Subject: Minutes for 63rd Protection Sub-Committee Meeting-reg

Minutes of
63rd Meeting of Protection Sub-Committee (PSC) of
Northern Regional Power Committee

Date and time of meeting : 29.09.2025 10.30 Hrs.

DR of 220 KV Ludhiana(PG)(end)-Laltokalan(PS) (PSTCL) Ckt-1

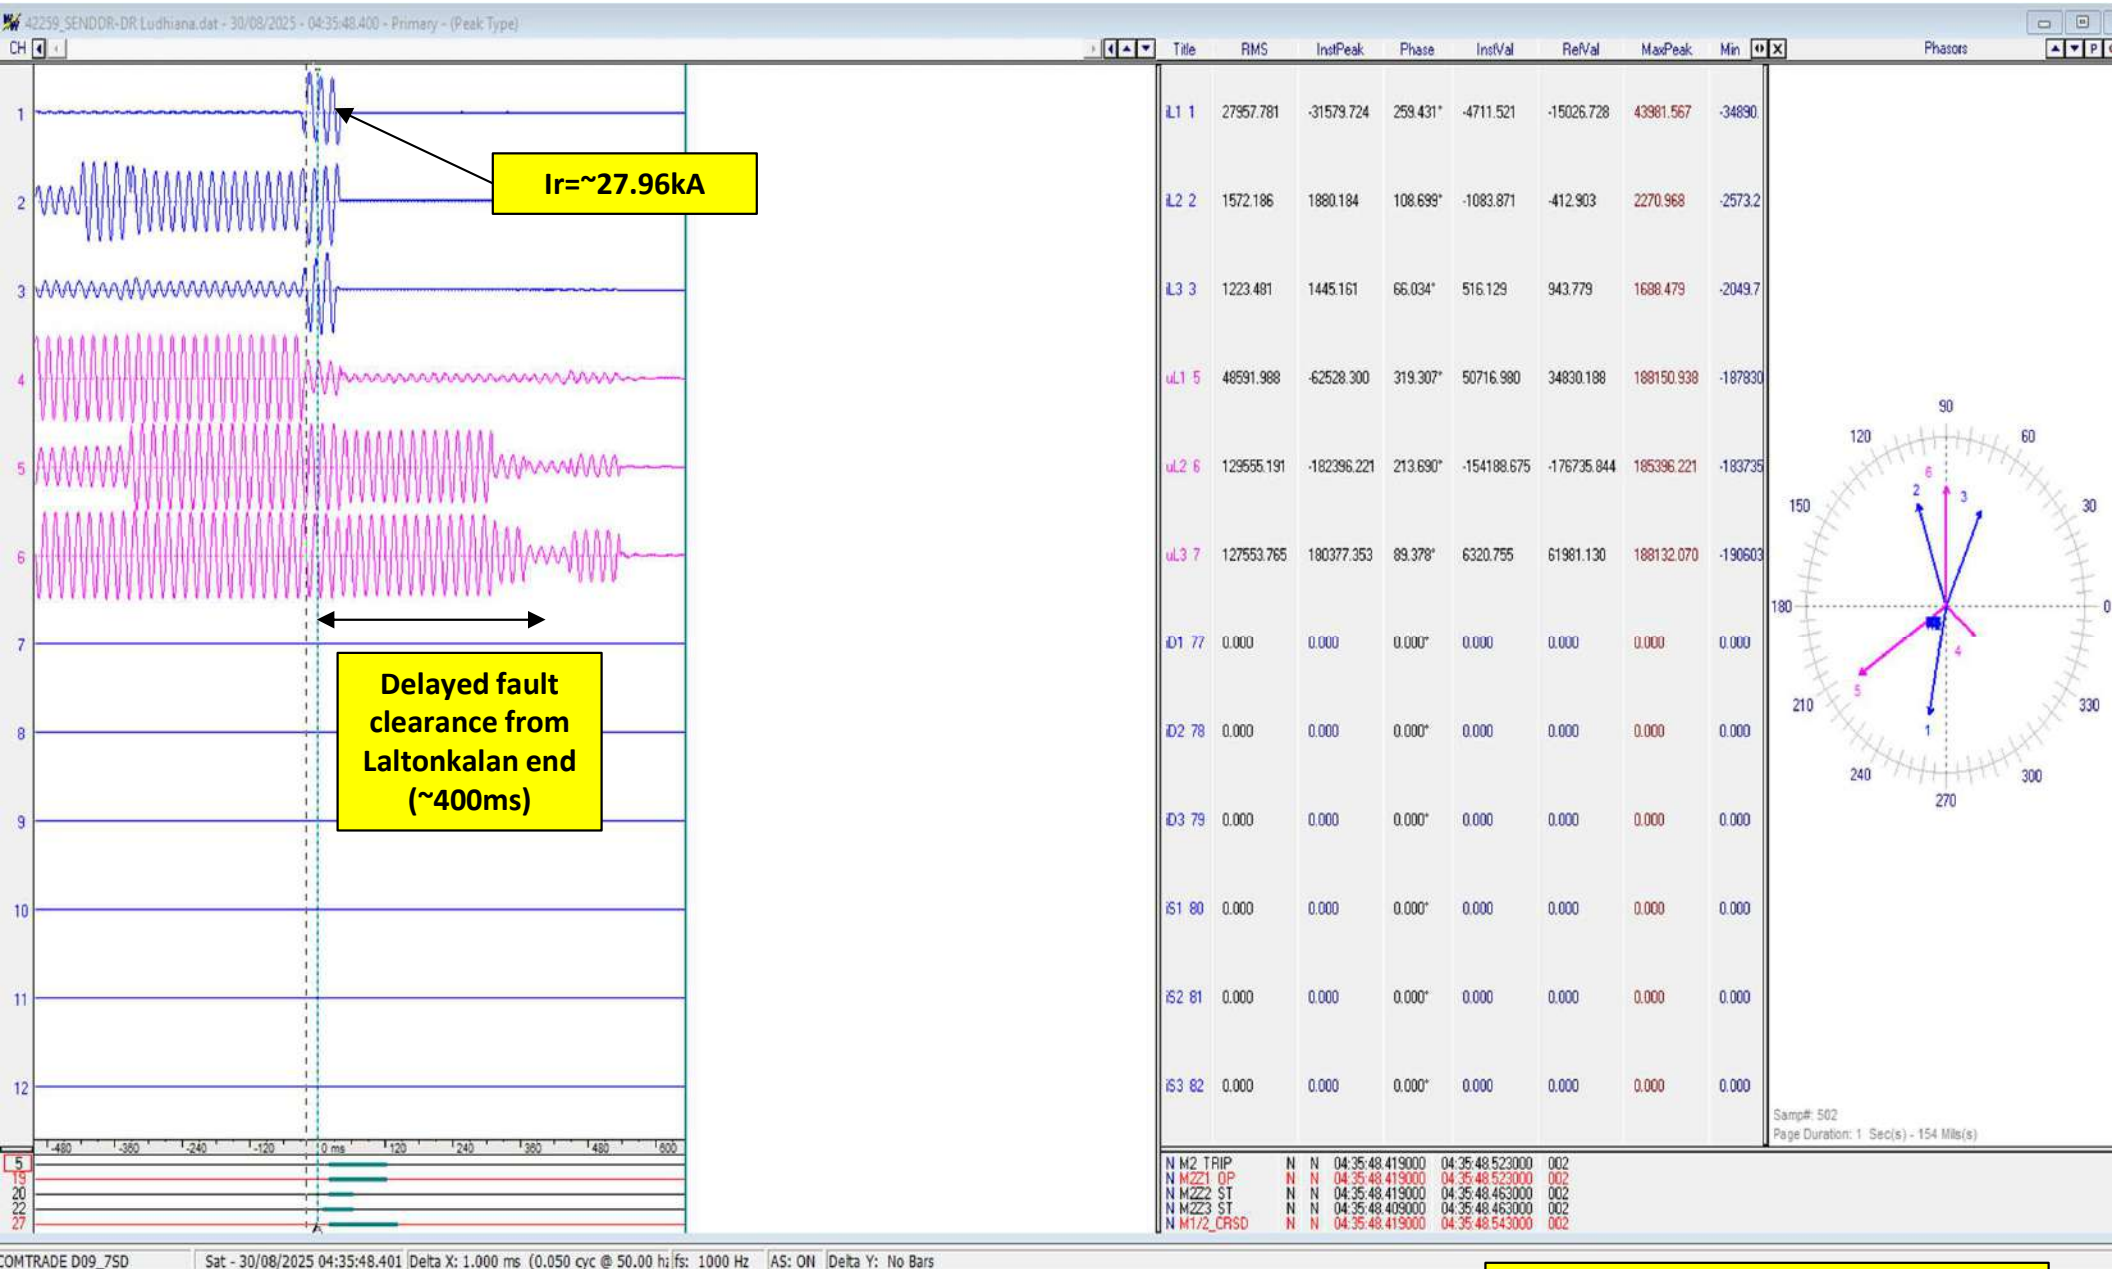
- ✓ R-N phase to earth fault. Fault current: $I_r \approx 27.96\text{kA}$.
- ✓ Zone-1 distance protection operated and carrier sent.
- ✓ A/R operation is not observed.

DR nomenclature need to be corrected
